AGENDA
City of Gig Harbor Design Review Board
Virtual Meeting of July 8, 2021 at 5:00 pm

1. **Gig Harbor Peninsula Historical Society, P.O. Box 744, Gig Harbor, WA 98335: HARBOR HISTORY MUSEUM – MARITIME GALLERY ENCLOSURE: (PL-DR-21-0164)** The applicant is proposing to enclose an exterior wall of the existing Maritime Gallery at the Harbor History Museum. There are not changes to the roof profile or building massing, all work is to be performed within the existing building footprint with no additions proposed. The enclosure walls were original proposed as part of the original land use and building applications and was noted as a “Future Phase”. The proposed enclosure maintains the transparency of the original design intent, however, the amount of glazing has been reduced in order to comply with the recently adopted 2018 Washington State Energy Code.

**PLANNING DIVISION
DRB PRE-APPLICATION STAFF MEMO**

RE: PL-DR-21-0164 – Harbor History Museum – Maritime Gallery
Enclosure – 4121 Harborview Drive
Public Meeting Date: July 8, 2021

A4.1

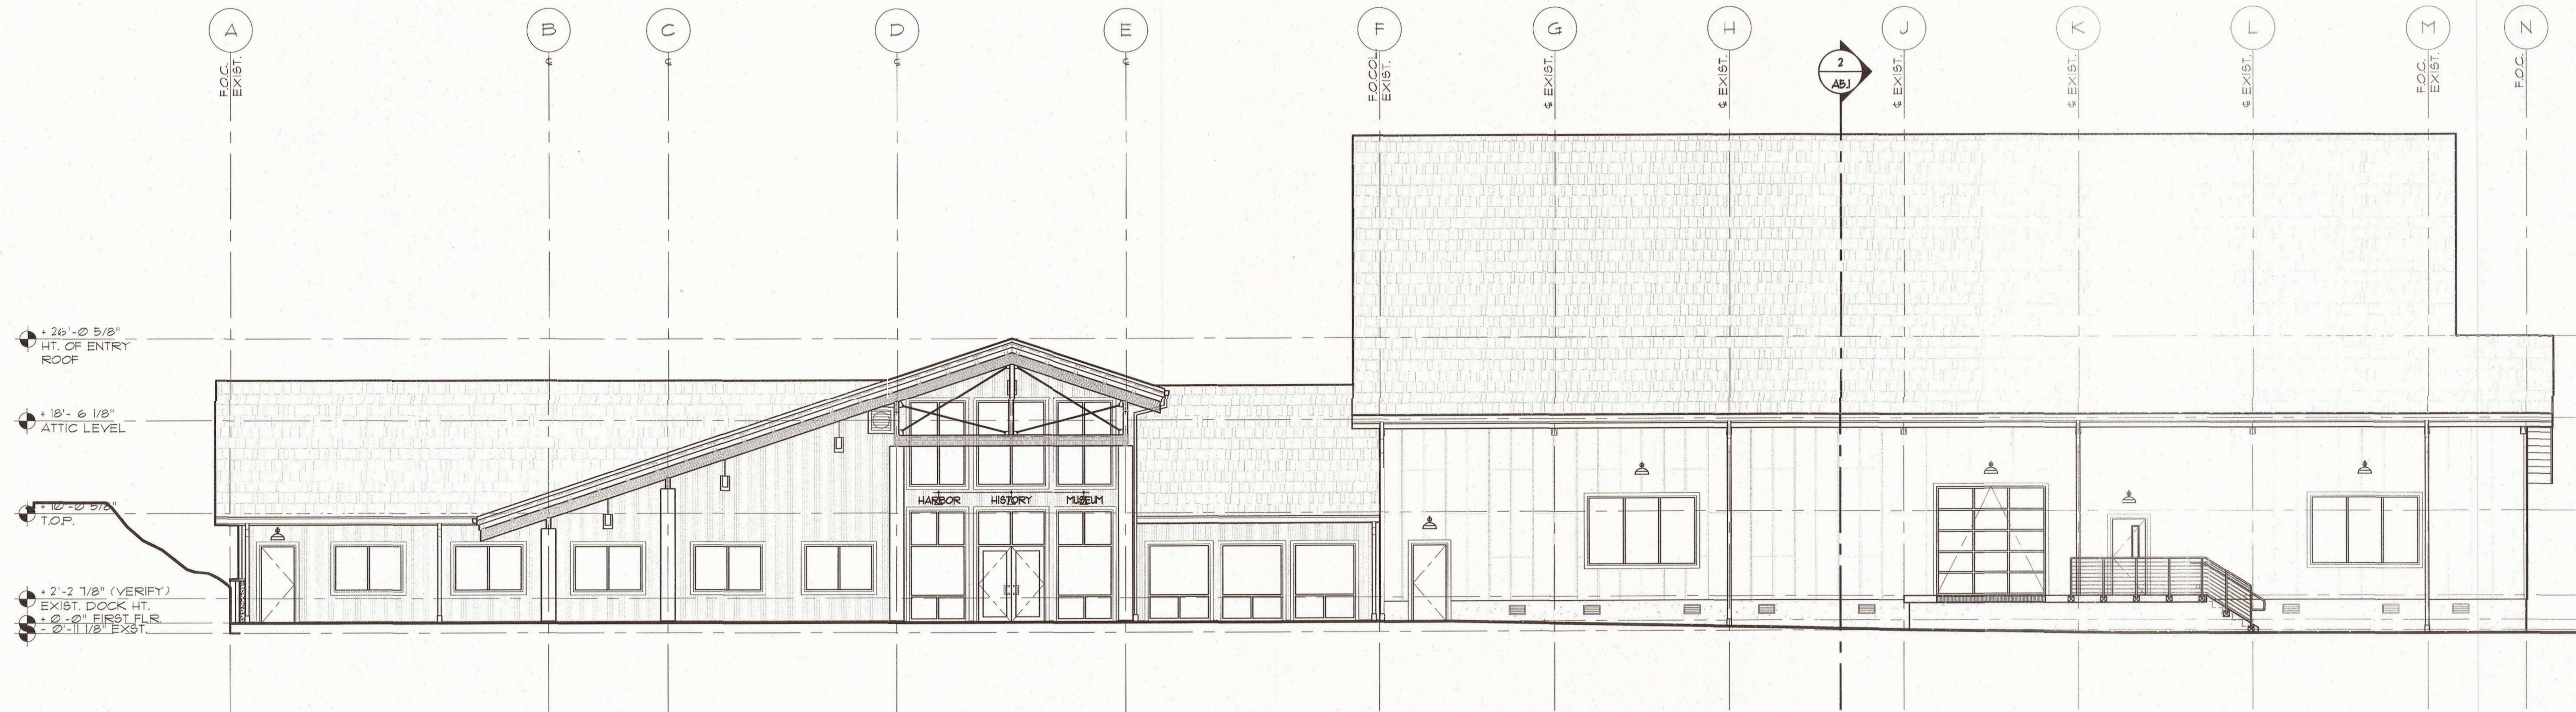
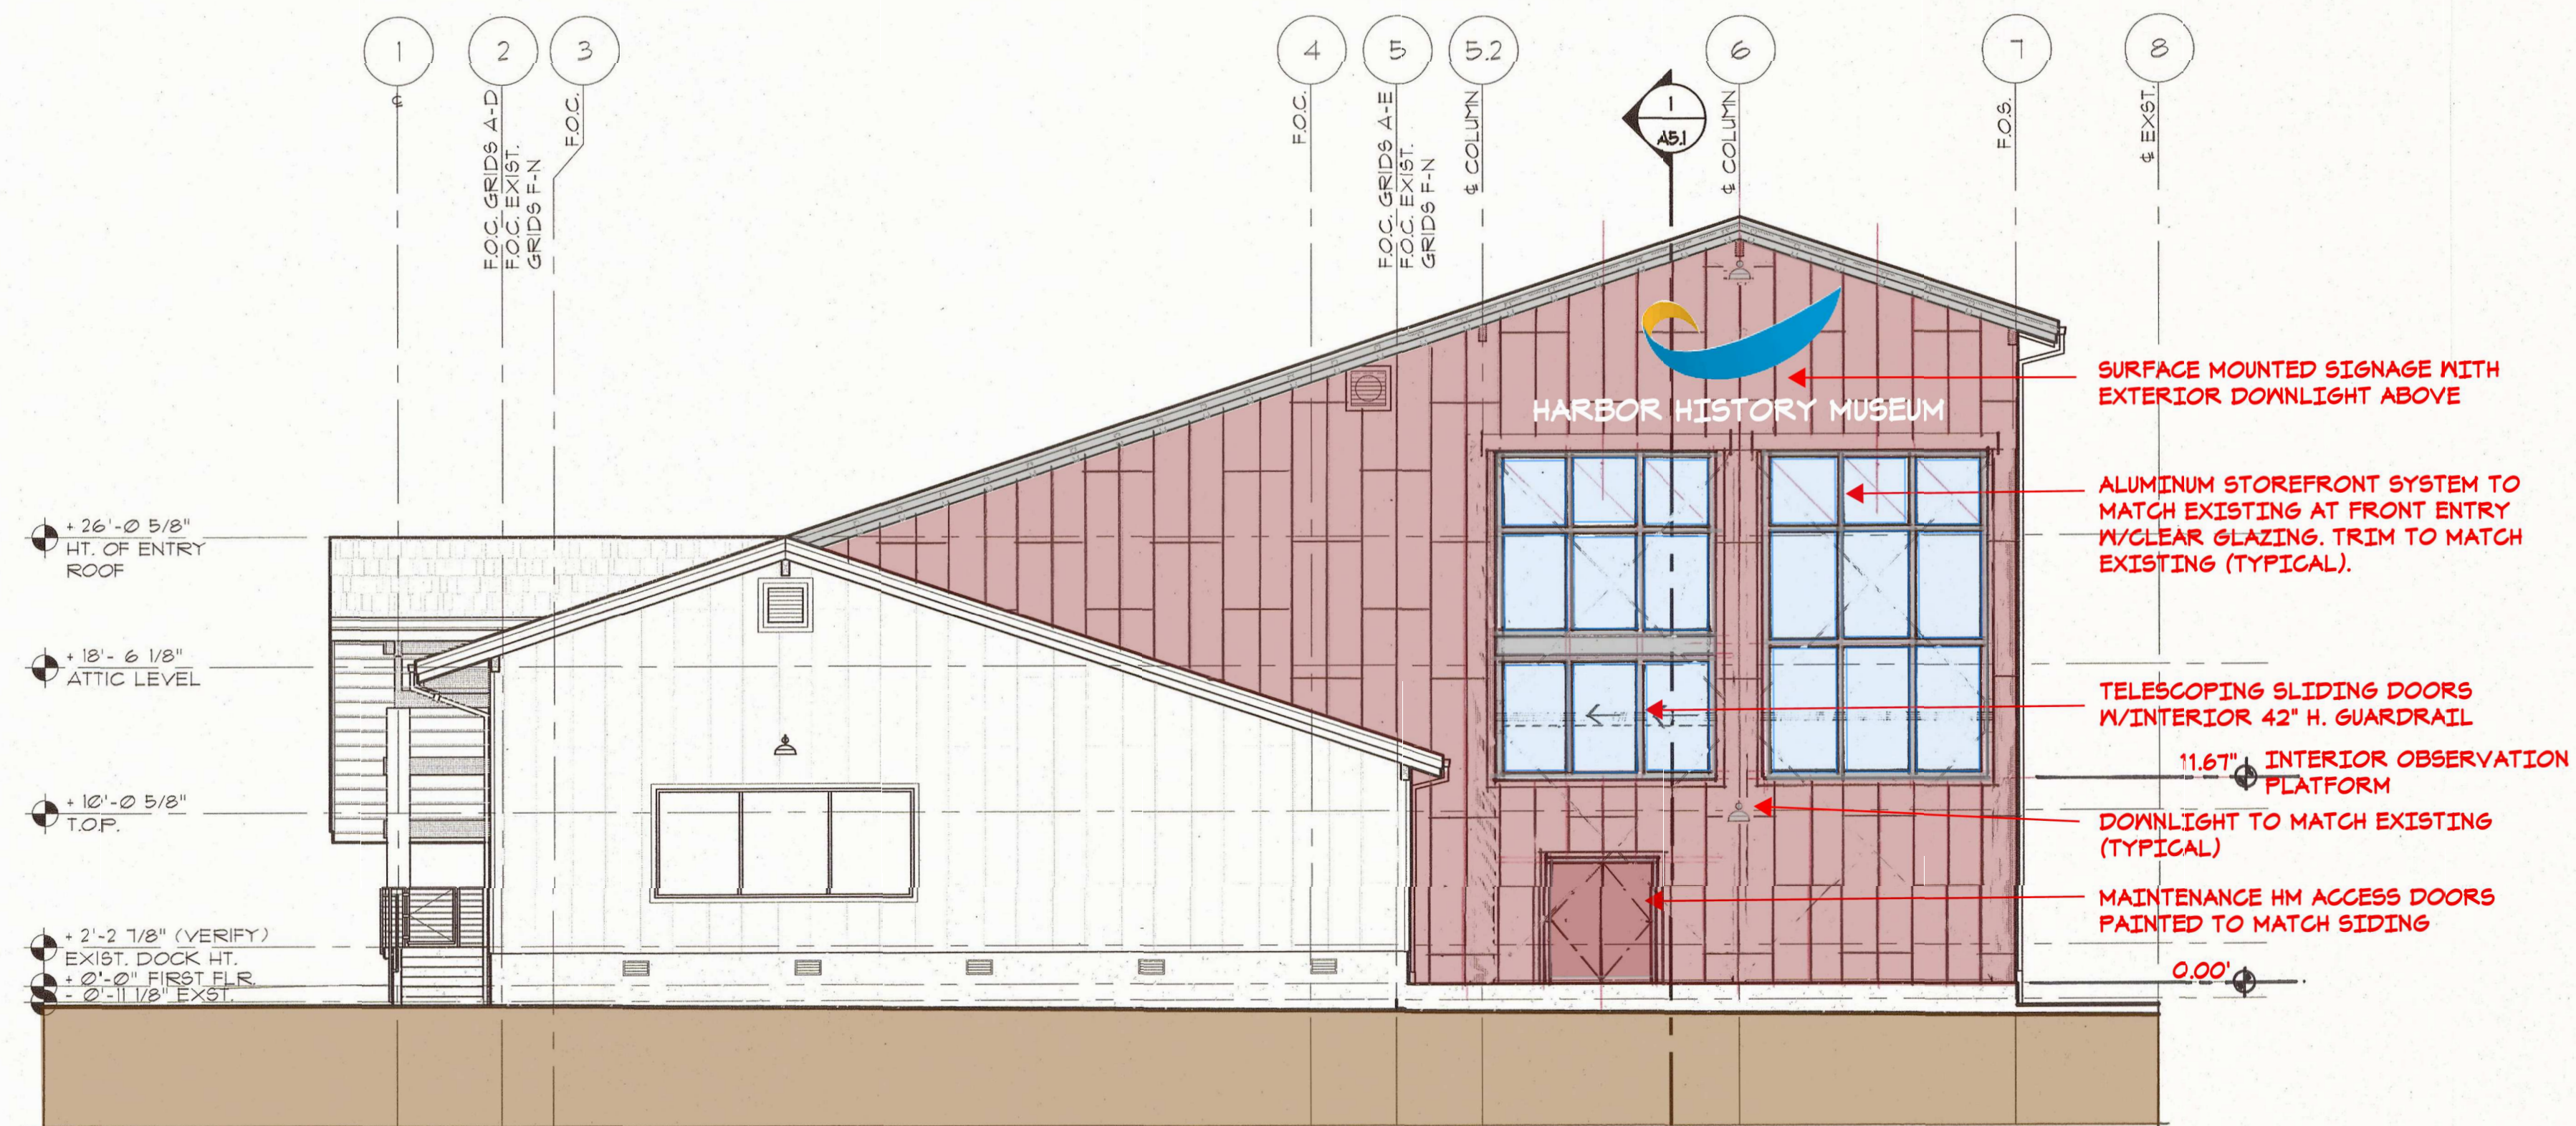
The History Museum received extensive design review and subsequent approval of it's current building and this enclosure was considered during that review. The proposed siding and trim matches that which exists and was previously approved.

The History Museum received extension design review and subsequent approval of it's current colors and the proposal matches those colors.
